MINOR VARIANCE REPORT

APPLICATION: A/099/2024 – Deferred from June 26, 2024

<u>Owner (s)</u>	<u>Agent</u>	<u>Location of Land</u>
Blythe Properties Holdings Inc.	Jason Huether HDS Dwell Inc 20 GILMOUR Rd Puslinch ON, N0B 2J0	PLAN 513 PT LOT 15 26 Holyrood Ave Town of Oakville

A/099/2024 – Deferred from June 26, 2024 – 26 Holyrood Avenue (West District) (OP Designation: Low Density Residential and Waterfront Open Space)

Front Elevation Rendering (June 26, 2024) – 26 Holyrood Avenue

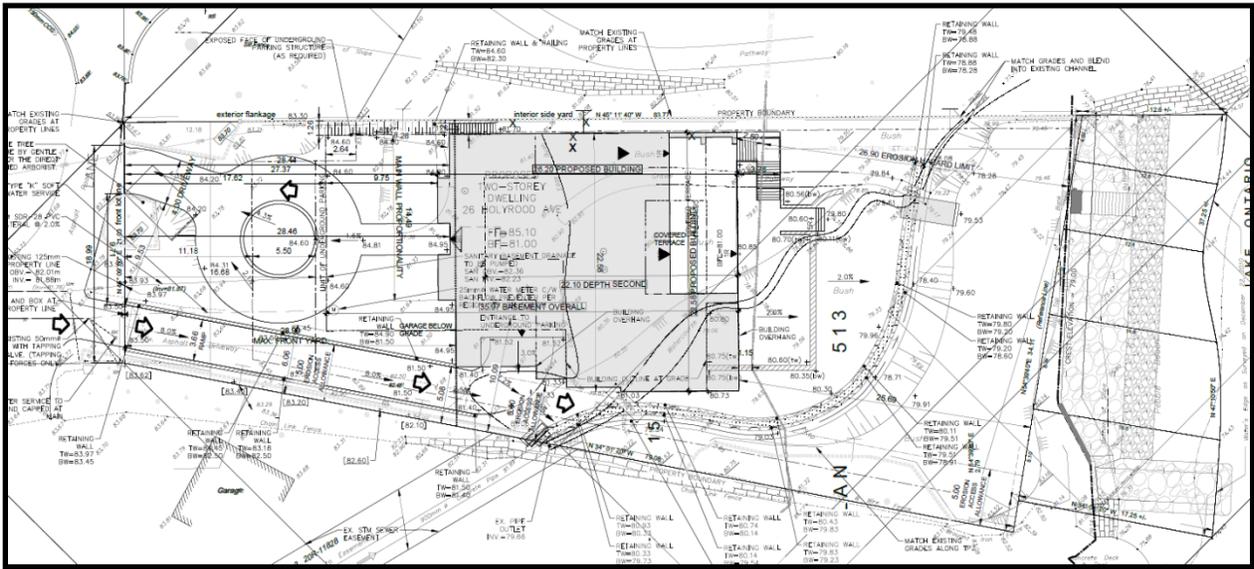
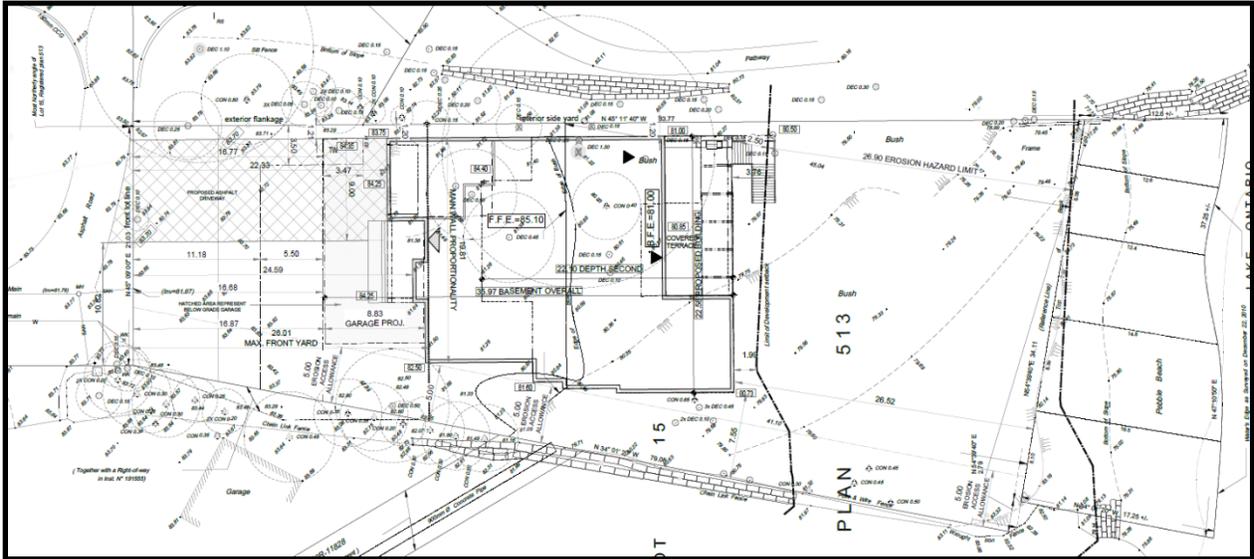
A revised minor variance application is now before the Committee for consideration. The revised application results in modifications to the proposed dwelling's front and flankage façades, along with the removal of a secondary driveway access and associated below grade garage entrance. This has resulted in the elimination of one variance in its entirety and the reduction in magnitude of others.

Overall, staff are satisfied that the proposed revisions to the dwelling’s architectural features, the removal of the second driveway access, and the façade articulation and treatments address previous concerns with the application. Additionally, the additional review undertaken regarding grading has confirmed that this is a unique site that cannot be re-graded to provide for a below grade basement level, which has been considered as context in evaluating the below revised variances:

A comparison between the initial proposal heard before the Committee on June 26, 2024, and the revised proposal have been illustrated in the site plan drawing and elevation drawings/3D renderings below.

Excerpt of Site Plan indicating location of flankage lot line

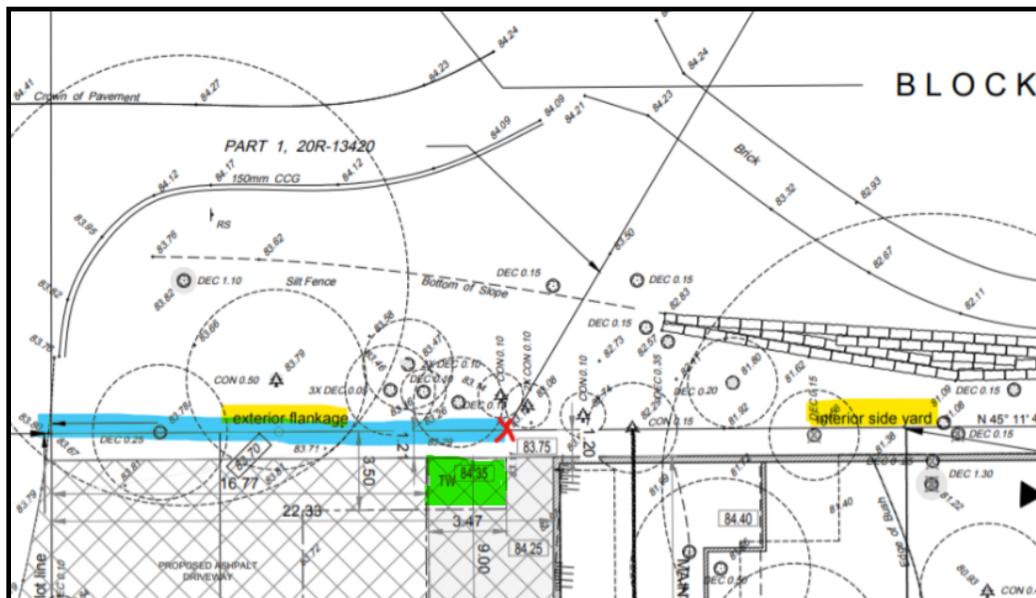
Variance #3 – Minimum Flankage Yard (No Objection) – Decrease from 3.5 metres to 1.20 metres

The intent of regulating the minimum flankage yard setback is to ensure adequate separation distances from the public right-of-way, maintain relatively consistent setbacks along the street, and to ensure there are no negative impacts on drainage.

In this instance, the curve of Holyhood Avenue results in a portion of the easterly lot line to be considered a flankage yard while the remainder is considered an interior lot line. The excerpt below indicates the flankage yard in blue and the portion of the dwelling that requires relief in green. The dwelling is proposed to be setback 1.20 metres from the easterly lot line. The majority of the dwelling is adjacent to the interior side yard and complies with the minimum setback of 1.2 metres. A portion of the underground garage falls within the flankage yard, which is 2.30 metres less than the minimum requirement under the By-law.

On-site stormwater management, grading, swales, and drainage will be dealt with through the Minor Site Plan process. If it is proven that the reduced flankage yard setback is not conducive to proper Development Engineering protocols, then the design of the dwelling will need to change prior to the issuance of a building permit. To that end, one of the conditions of approval that is being recommended is that the proposal be approved in "general accordance" with the plans which allows for some minor revisions and adjustments to be made to the plan at the Minor Site Plan and Building Permit stage to address these comments.
